CITY OF ALBUQUERQUE

**RE: Cibola Loop New Library
Cibola Loop & Ellison NW
Drainage Analysis Report
Engineer's Stamp Date: none (8/7/19)
Hydrology File: A13D011A**

CIBOLA LOOP DRAINAGE ANALYSIS AND FEASIBILITY REPORT – PHASE 1

95% Review Submittal

Cibola Loop Drainage Analysis Option 3
Free Discharge to Coors Bypass Pond
City of Albuquerque, New Mexico
August, 2019

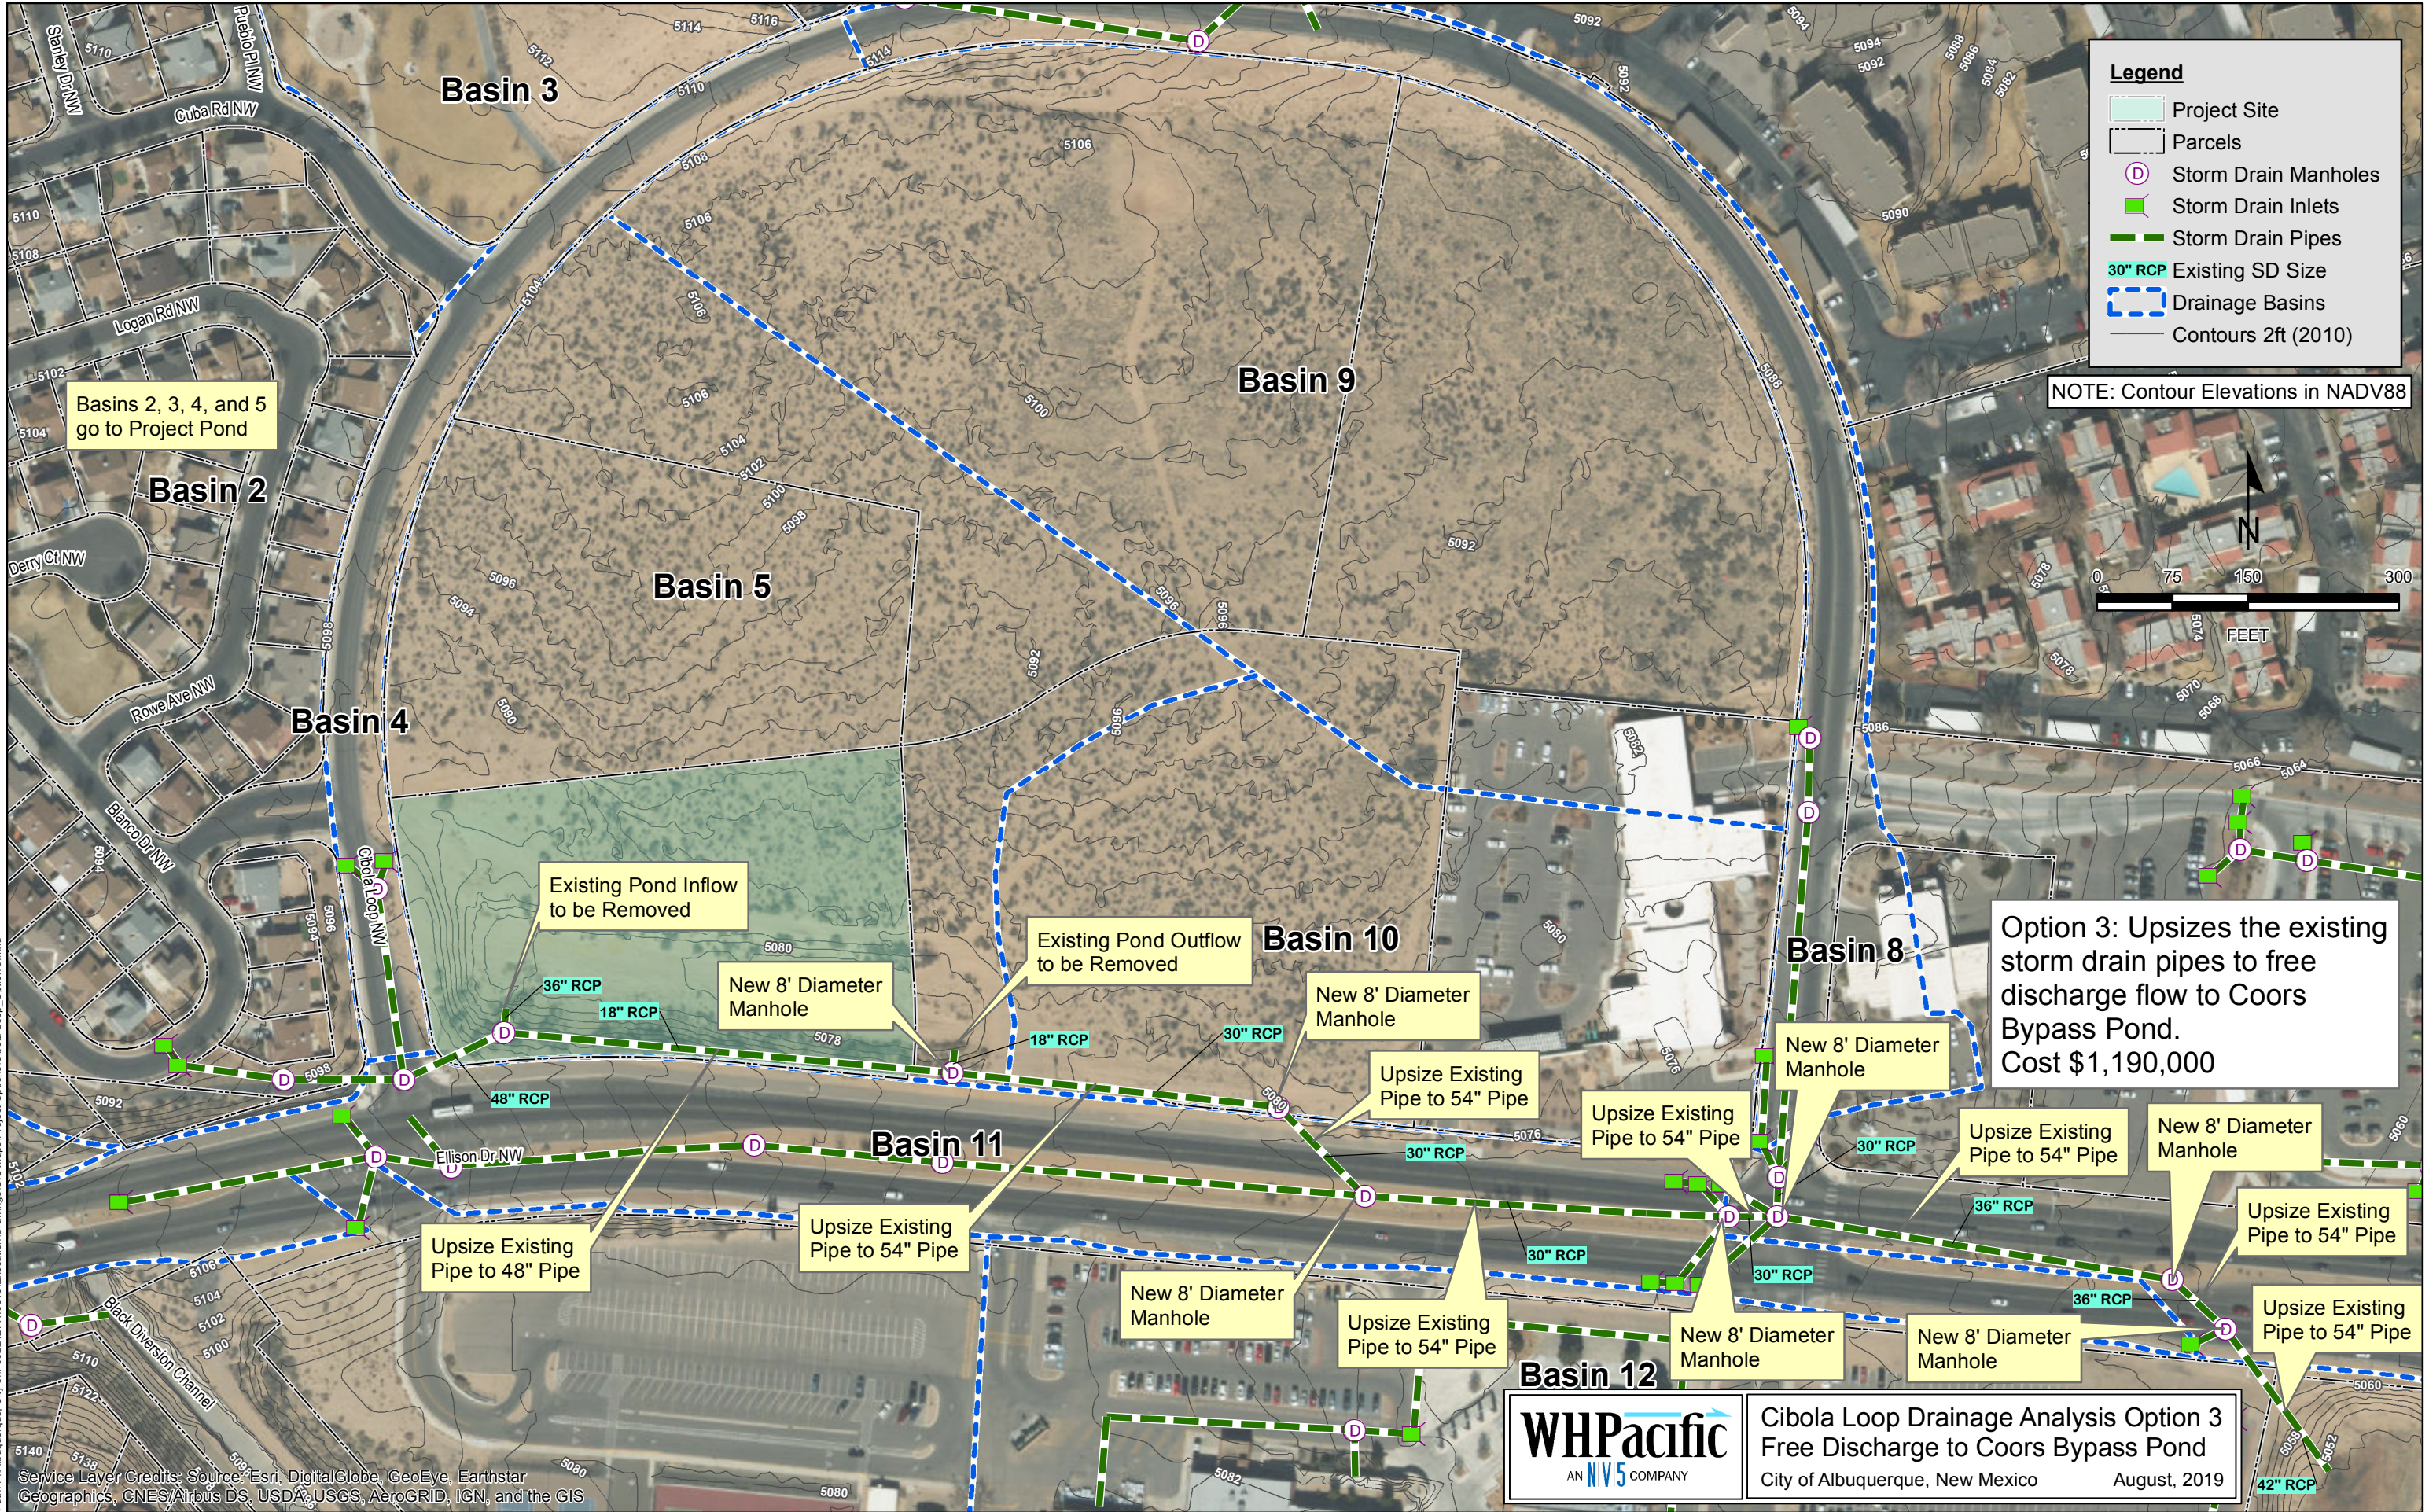
10. The cost of Option 3, (free discharge and increased pipe size) seems low; but this option really isn't feasible until significant capacity in the Coors pond can be proven.
